# intel® Technical Advisory

TA-799-1

## Intel® Server Chassis SR1450 Drive Bay Interference with the AXXFLOPHDDTRAY (Hard-Drive-to-Floppy Conversion Kit) Accessory

## 1. Removal of the drive carrier stop pin

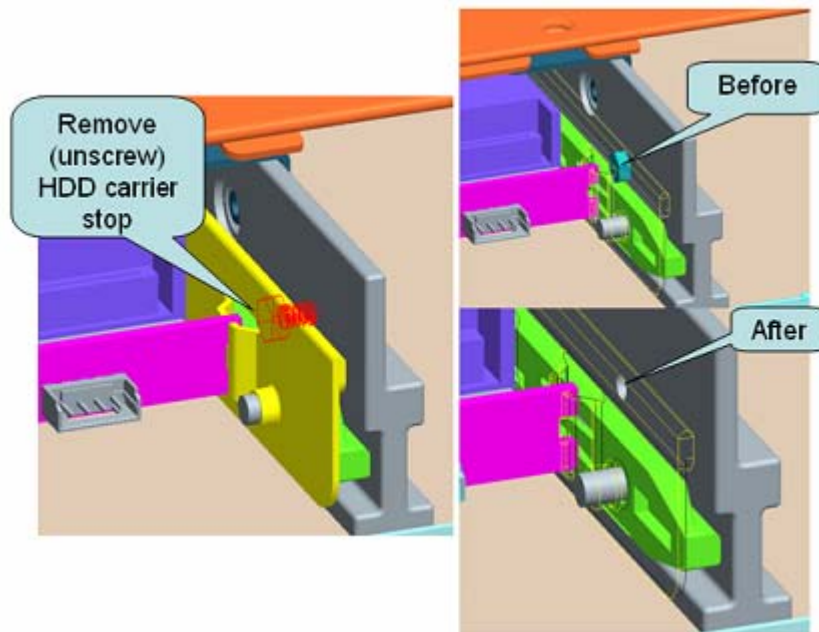
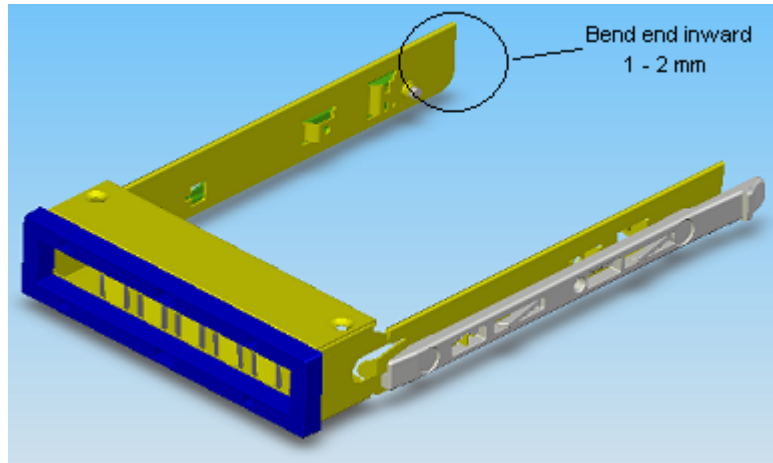
The interference is created by a drive carrier stop pin inside the drive bay of the Server Chassis SR1450. The stop pin interferes with the cage of the Hard-Drive-to-Floppy Conversion Kit and prohibits its full insertion into the server chassis.

The drive carrier stop pin in the drive bay of the SR1450 may be safely removed to allow the full insertion of the Hard-Drive-to-Floppy Conversion Kit as follows:

- Remove the Server Chassis SR1450 cover and front outer bezel (if present).
- Remove any hard disk drive or carrier from the middle drive bay of the chassis.
- Viewing from the rear of the Server Chassis SR1450, locate the carrier stop pin in the rail assembly of the middle drive bay.
- Using needle-nose pliers, grasp the drive carrier stop pin and unscrew it from the drive bay as shown.

- Push the Hard-Drive-to-Floppy Conversion Kit into the chassis until it is completely installed in the Server Chassis SR1450 (clicks into place).
- Complete the installation according to the instructions contained in the conversion kit.

## 2. Flexing the cage of the conversion kit during installation.

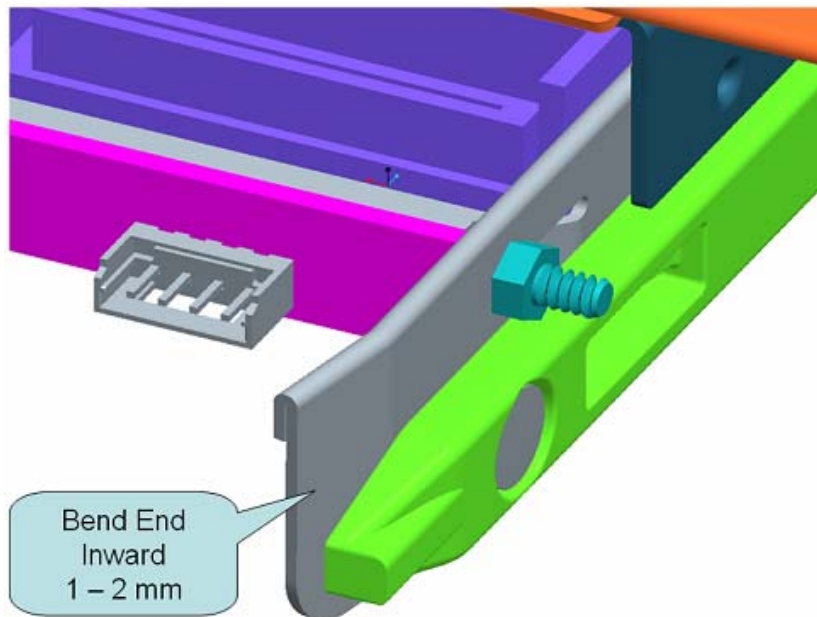
The conversion kit may be flexed during installation to allow its insertion in the chassis as follows:

- Remove the Server Chassis SR1450 front outer bezel (if present).
- Insert the cage of the Hard-Drive-to-Floppy Conversion Kit into the middle drive bay and push until it meets the stop pin.
- While pushing the Hard-Drive-to-Floppy Conversion Kit into the chassis, gently bend the left metal rail of the cage approximately 1 to 2 millimeters inward, as shown.

- Continue pushing the Hard-Drive-to-Floppy Conversion Kit into the chassis until the kit is completely installed (clicks into place) in the Server Chassis SR1450.
- Complete the installation according to the instructions contained in the conversion kit.
